NOTICE OF MEETING
PLANNING AND ZONING COMMISSION
6:00 P.M. – November 10, 2021
30360 Cougar Bend, Bulverde, TX 78163

MEETING AGENDA

PLANNING AND ZONING COMMISSION ITEM:
PC-21-15
Master Development Plan (MDP)
Amendment
Belle Oaks Ranch

PLANNING AND ZONING COMMISSION ITEM:
PC-21-21
FINAL PLAT
4S RANCH, UNIT 9A

MAJOR AMENDMENT TO MASTER DEVELOPMENT PLAN (SHEET 2)
 FOR
BELLE OAKS RANCH
 BULVERDE, TEXAS

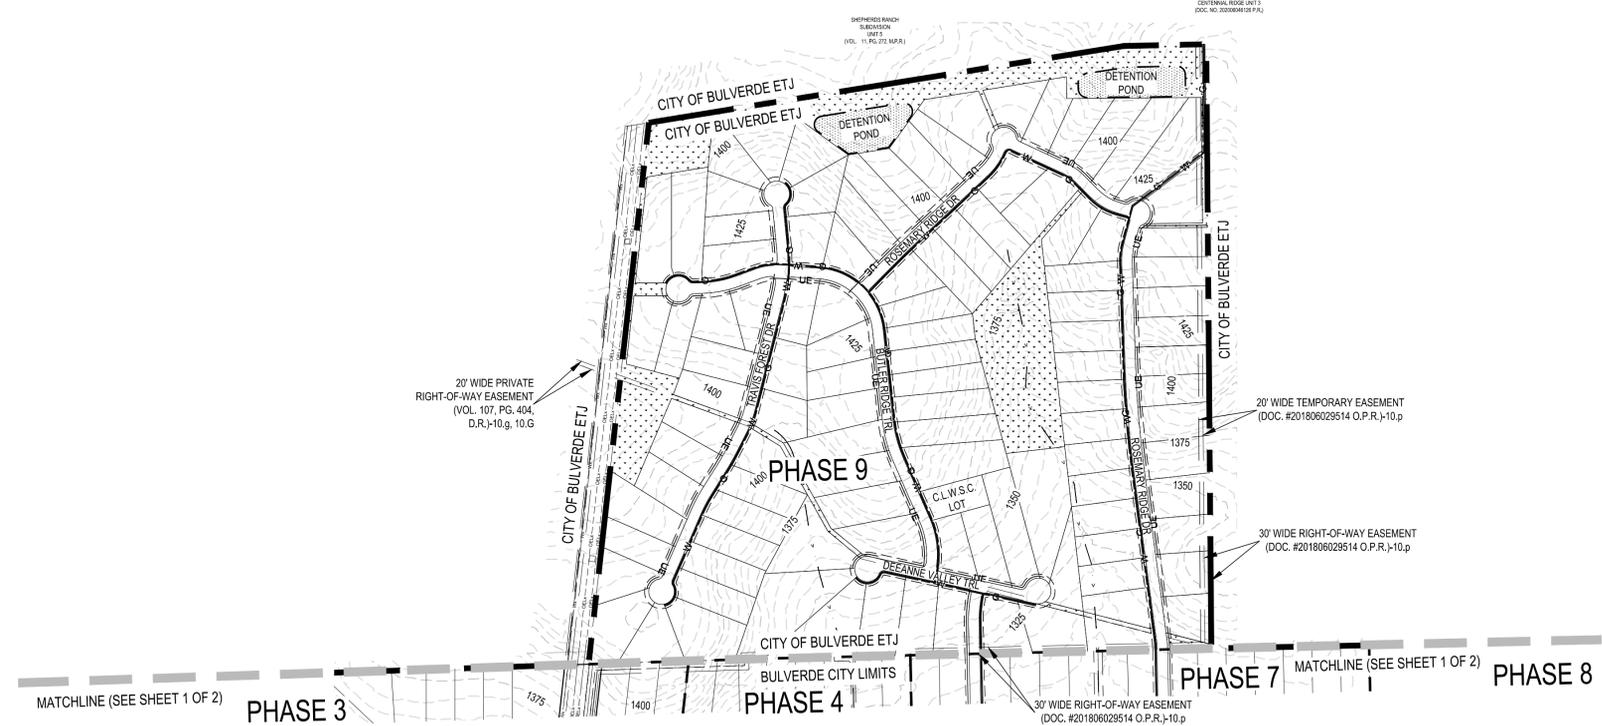
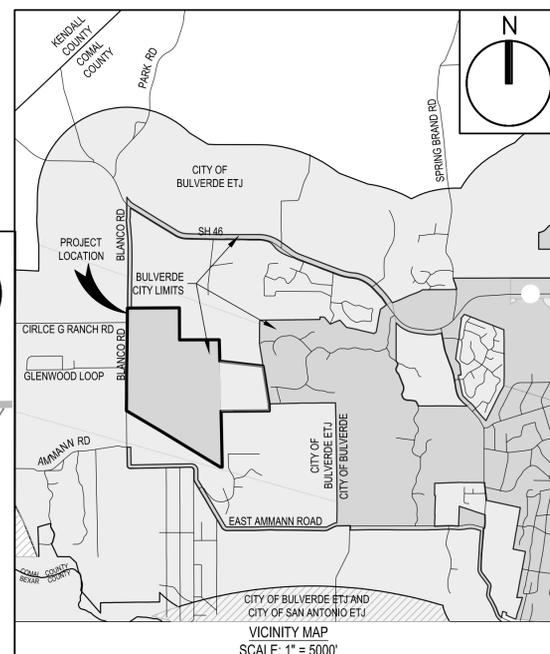
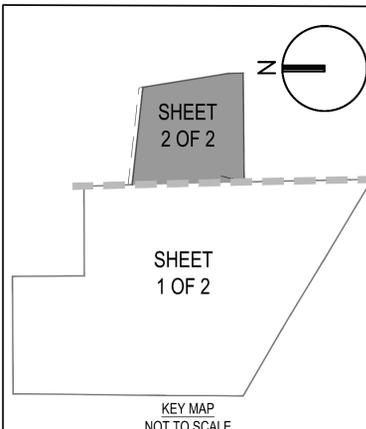
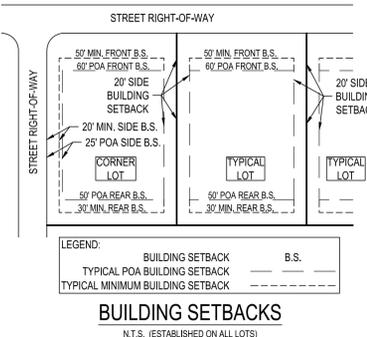
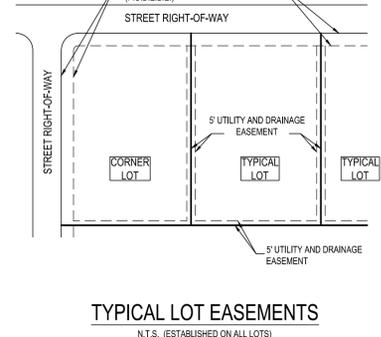
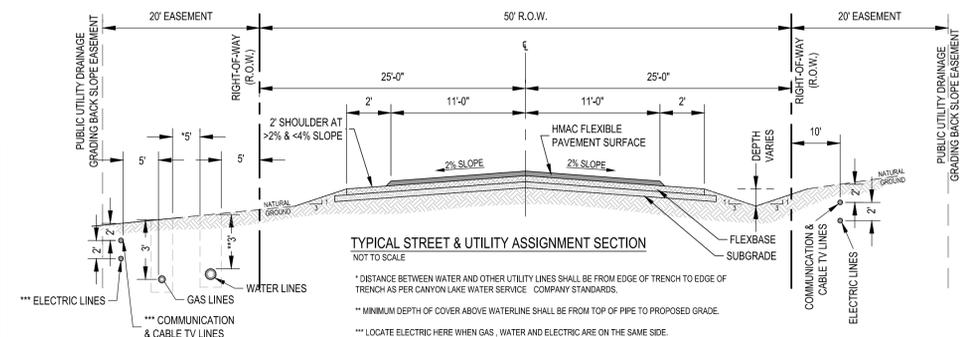
Missing phase ID's on plan map – [comment resolved... Phase ID's are shown on the MDP.](#)

Limits of Existing Stock Tank are missing – [comment resolved... Limits of the existing stock tank are shown on the MDP.](#)

Missing Detention Pond 1.2 from Phase 4 area. Check all other items from previously approved Master Development Plan, dated 10/15/19. There should not be any differences for Phases 1 through 8 except items that have been approved with detailed design plans (i.e. approximate limits of detention ponds). – [comment resolved... Detention Pond 1.2 from Phase 4 area is shown.](#)

- Is the 20.01 Acre Outparcel being changed? Does not match previous MDP. – [comment resolved... The outparcel \(now 20.35 acres\) matches the MDP as revised with the Phase 6 plat.](#)
- Utility linework is missing – [comment resolved... All utilities appear to be shown on the MDP.](#)
- a. There are no electric lines shown west of Maximino Ridge Rd.
 - b. Gas lines are not shown.
 - c. There are no lines shown in the 100' powerline easement crossing Thanksgiving Trl.
2. Dimensions per Subdivision Ordinance Section 1.05(a)(iii)(13) are not provided. – [comment resolved... the acreage of the outparcel was provided.](#)
 3. Phasing per Subdivision Ordinance Section 1.05(a)(iii)(19) is not provided. – [comment resolved... Note 10 was added to the MDP and provides the order the phases will be constructed.](#)
